PLANNING COMMISSION
DATE: 11/24/14
AGENDA ITEM: 4A – PUBLIC HEARING
CASE # 2014-48

ITEM: InWood PUD – Preliminary Plat and Preliminary PUD Plan

SUBMITTED BY: Kyle Klatt, Community Development Director

InWood—Trail and Sidewalk Plan

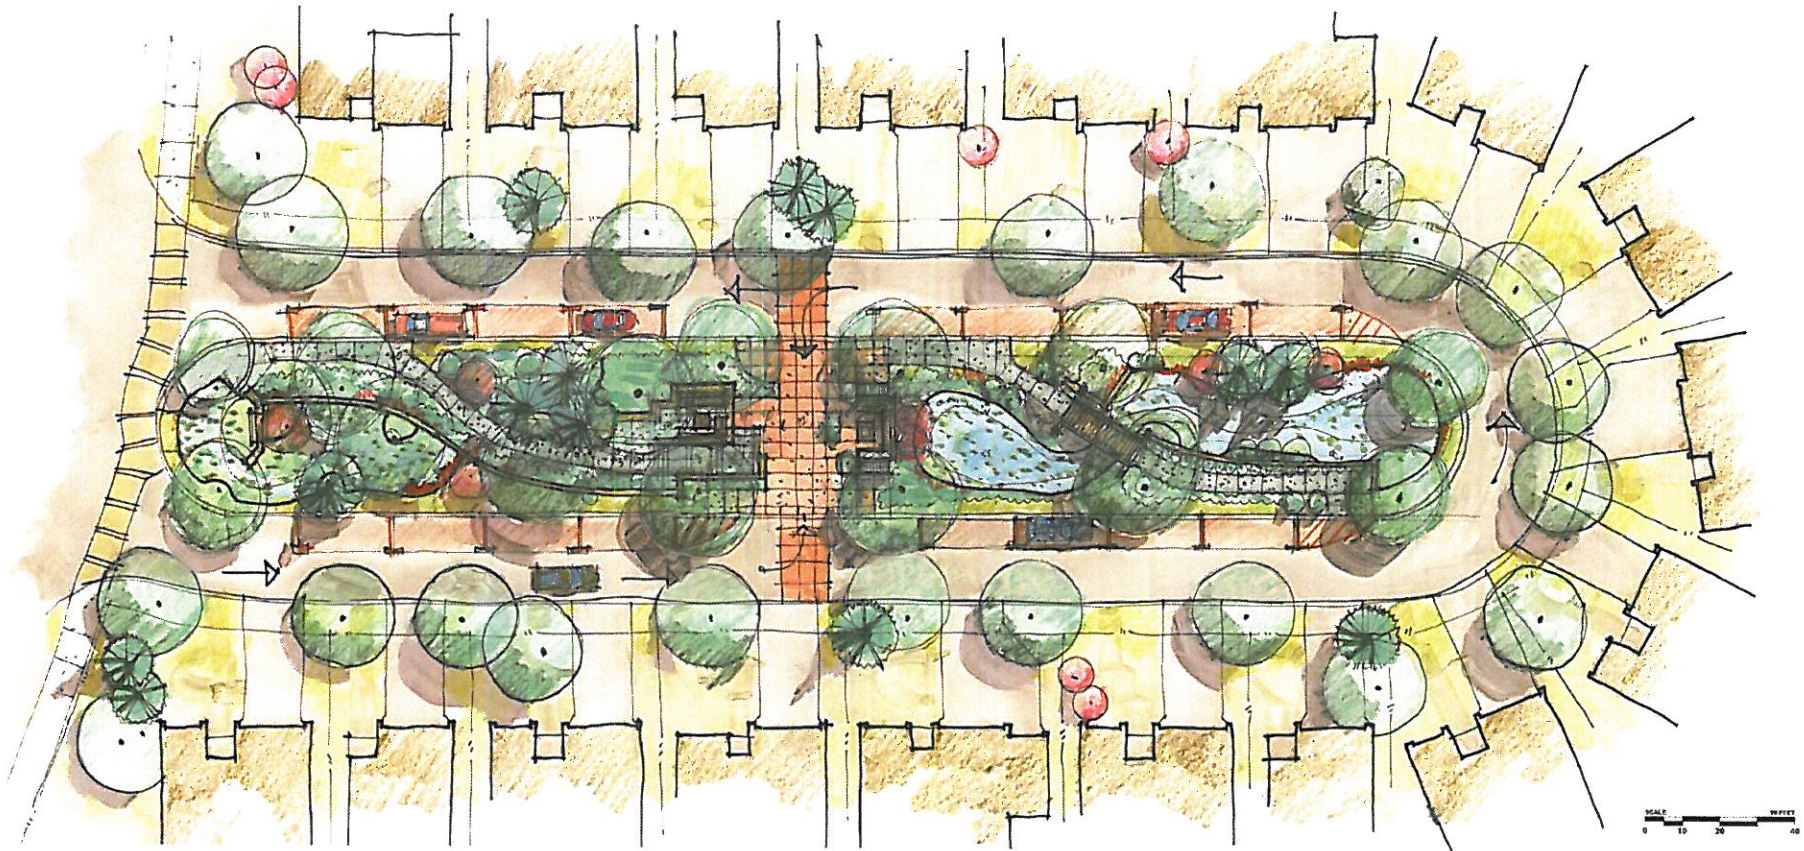
- **Trails.** In order to help better illustrate the location of all trails and sidewalks planned within the development the developer has submitted a specific color plan illustrating the location of these improvements throughout the project area. Staff would like to note that although the developer is not planned to install any trails beyond those shown along Inwood Avenue and 10th Street, the City's Trail Plan does depict a City trail extending from this intersection to the City's wide trail network to the south and east of this area. Based on this plan, Staff is recommending that the preliminary development plans be updated to include a trail connection either along Inwood Avenue from 10th Street to either 5th Street or to the planned trail segment along 9th Street or a trail connection along 10th Street that connects Street B and the trail to the east to Inwood Avenue.

preliminary development plans be updated to include a trail connection either along Inwood Avenue from 10th Street to either 5th Street or to the planned trail segment along 9th Street or a trail connection along 10th Street that connects Street B and the trail to the east to Inwood Avenue.

InWood— Street N Park Concept

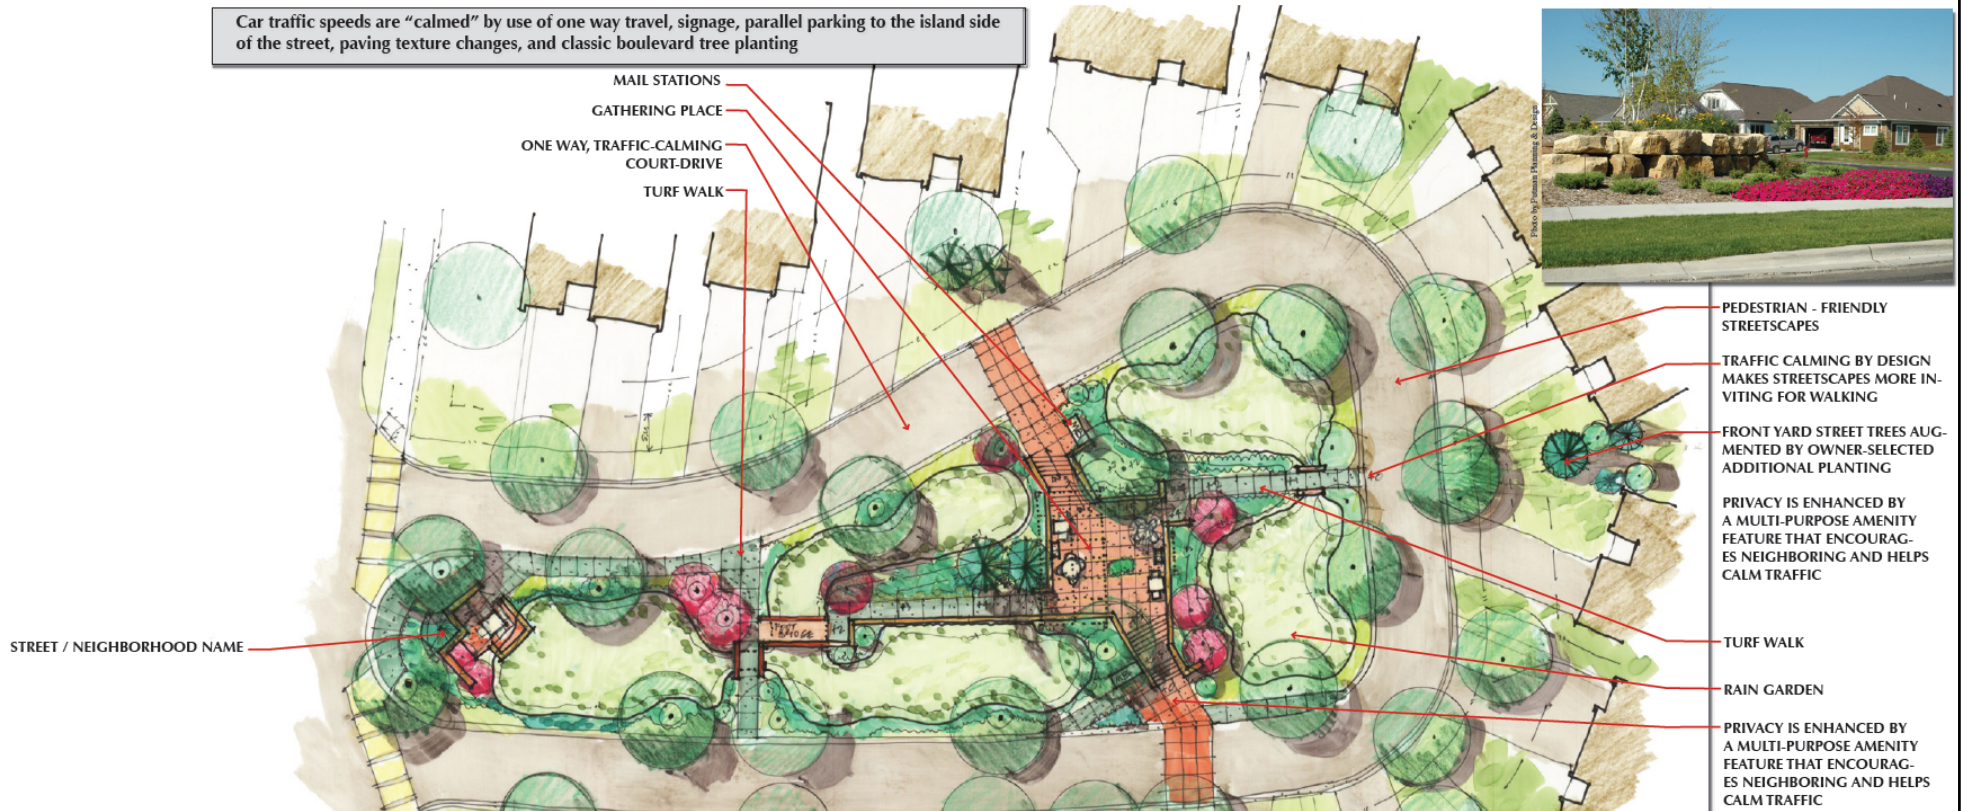
- In response to the Planning Commission request for additional small park in the northwest corner of the development the developer has submitted a concept for Outlot P (Street N) that shows how this area could be used for public gathering space associated amenities. The applicant has accurately pointed out that the City's reviewing bodies did have differences of opinions concerning the size and most appropriate improvement for this area.
- As a response to a specific condition of approval, the developer has proposed specific design considerations for the single family homes. These standards will be incorporated as part of the City approval.
